TRANS/WP.29/2004/39
31 March 2004

**PROPOSAL FOR DRAFT 10 SERIES OF AMENDMENTS
TO REGULATION No. 13**

(Braking)

Transmitted by the Working Party on Brakes and Running Gear (GRRF)

Model A

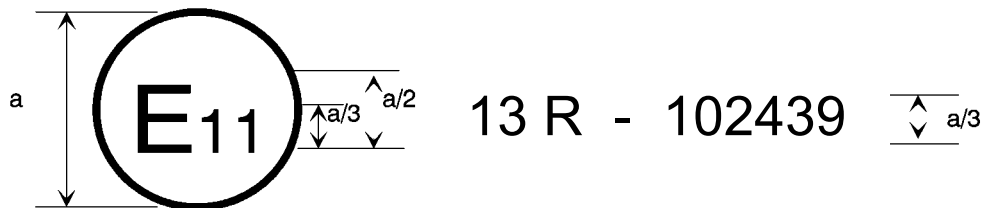
Annex 3, amend to read:

The above approval mark affixed to a vehicle shows that the vehicle type concerned has, with regard to braking, been approved in the United Kingdom (E 11) pursuant to Regulation No. 13 under approval number 102439. This number indicates that the approval was given in accordance with the requirements of Regulation No. 13 with the 10 series of amendments incorporated. For vehicles of categories M₂ and M₃, this mark means that that type of vehicle has undergone the Type-II test.

Model B

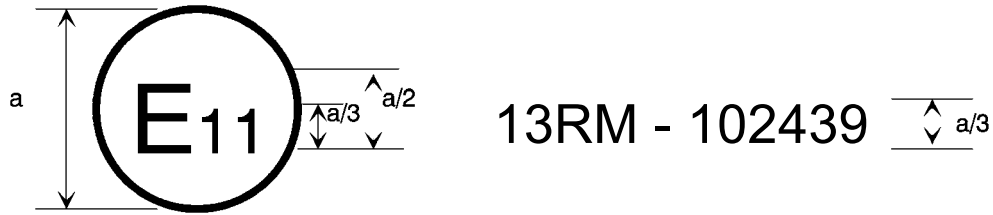
The above approval mark affixed to a vehicle shows that the vehicle type concerned has, with regard to braking, been approved in the United Kingdom (E 11) pursuant to Regulation No. 13. For vehicles of categories M₂ and M₃, this mark means that the type of vehicle has undergone the Type-IIA test.

Model C

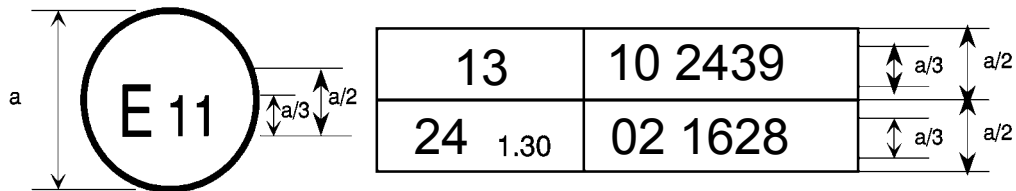
The above approval mark affixed to a vehicle shows that the vehicle type concerned has been approved in the United Kingdom (E 11) pursuant to Regulations Nos. 13 and 24 1/. (In the case of the latter Regulation the corrected absorption coefficient is 1.30 m⁻¹.)

"DIAGRAM 2

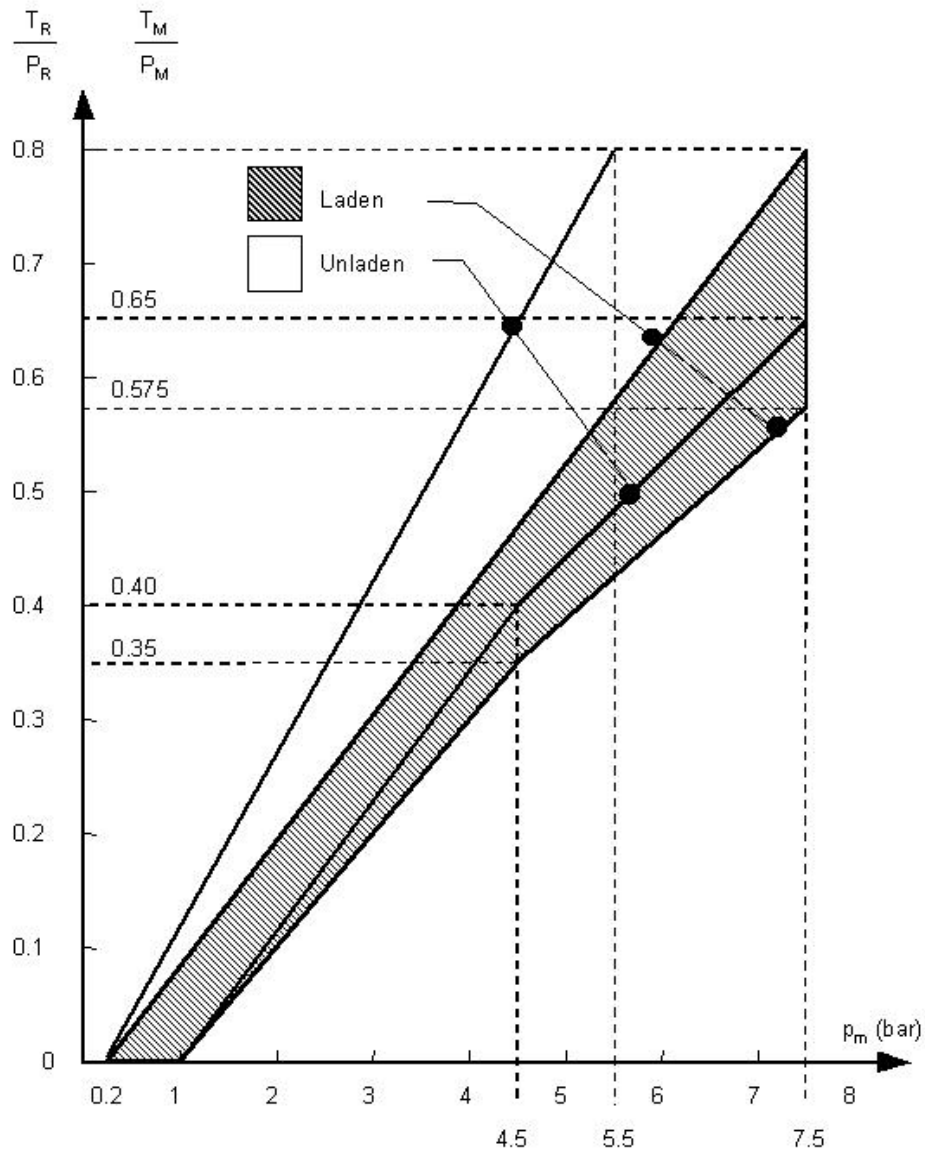
Diagrams 2, 3 and 4A, amend to read:

TOWING VEHICLES AND TRAILERS
(except tractors for semi-trailers and semi-trailers)
(see paragraph 3.1.5.1. of this annex)

Note: The relationships required by the diagram shall apply progressively for intermediate states of loading between the laden and the unladen states and shall be achieved by automatic means.

DIAGRAM 3

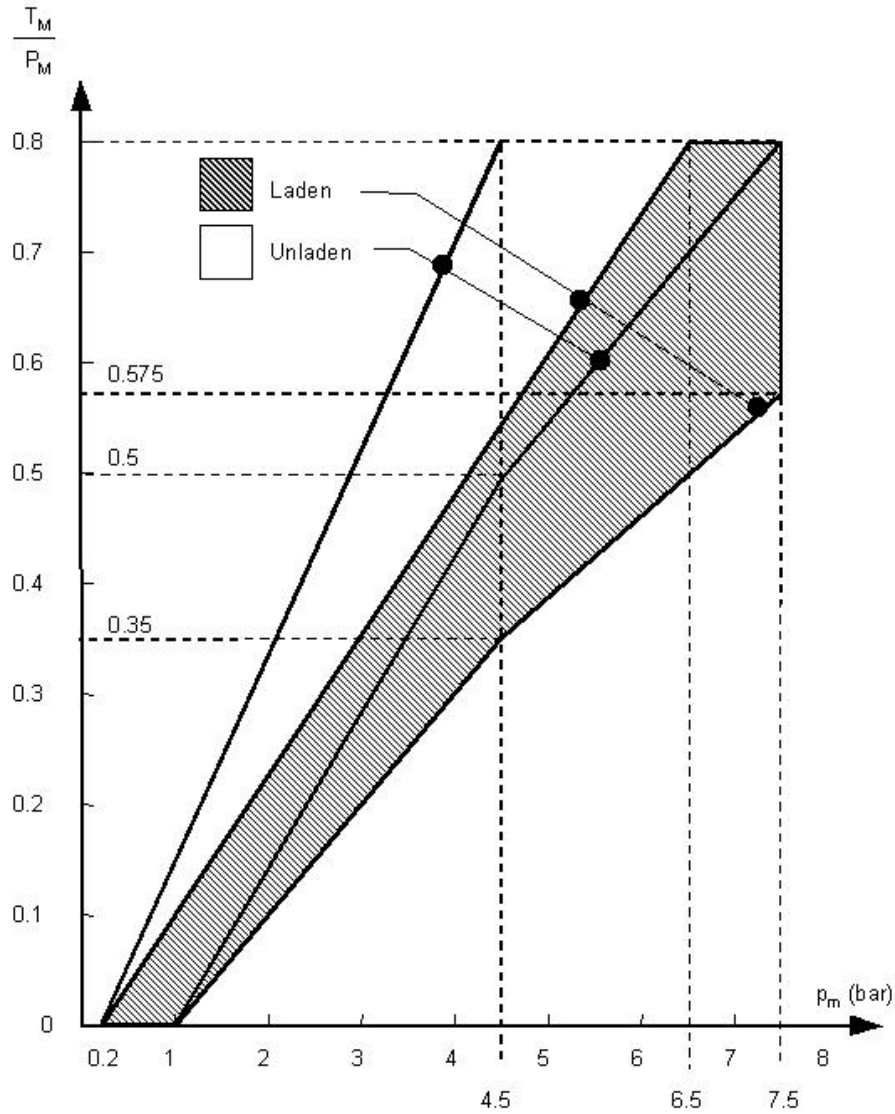
TRACTORS FOR SEMI-TRAILERS
(see paragraph 3.1.6. of this annex)

Note: The relationships required by the diagram shall apply progressively for intermediate states of loading between the laden and the unladen states and shall be achieved by automatic means.

DIAGRAM 4A
SEMI-TRAILERS
(see paragraph 4. of this annex)

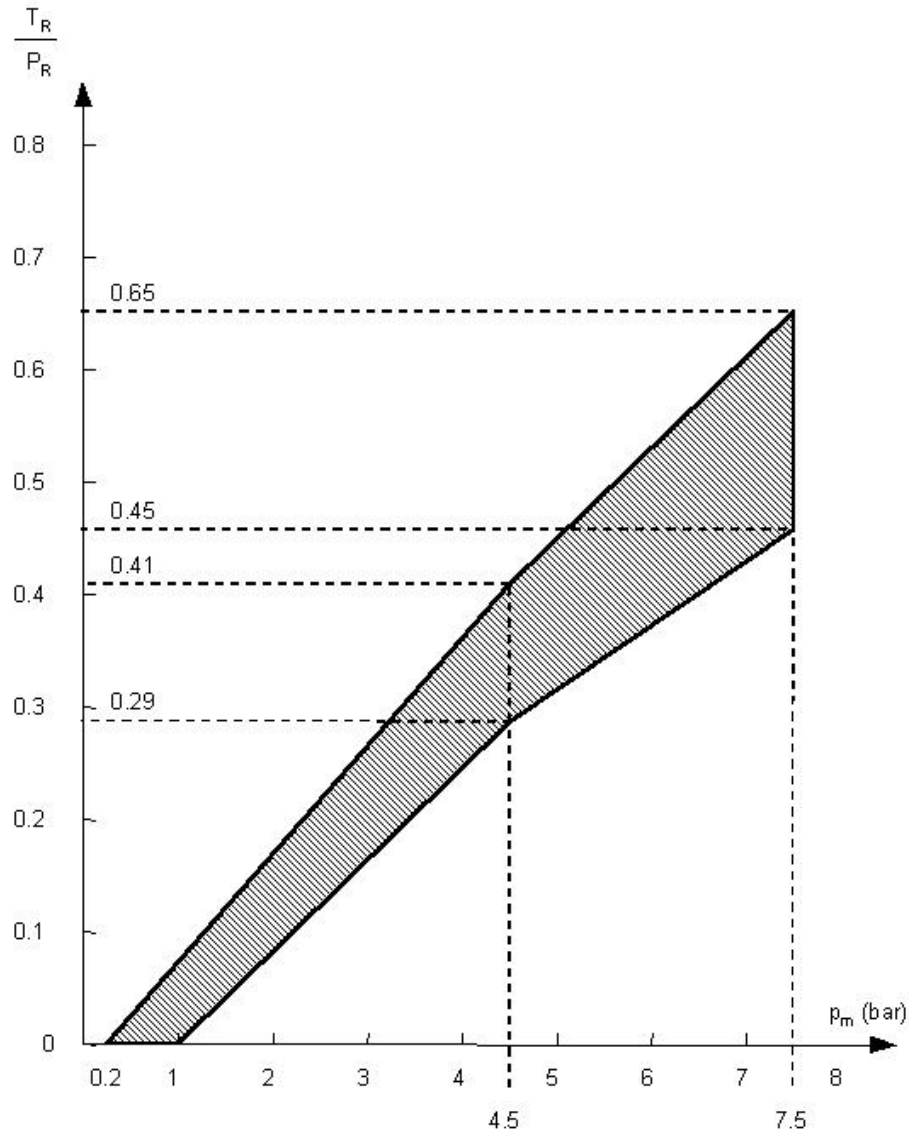
Note: The relation between the braking rate T_R/P_R and the control line pressure for the laden and unladen conditions is determined as follows:

The factors K_c (laden), K_v (unladen) are obtained by reference to diagram 4B. To determine the areas corresponding to the laden and unladen conditions, the values of the ordinates of the upper and lower limits of the hatched area in diagram 4A are multiplied by the factors K_c and K_v respectively."
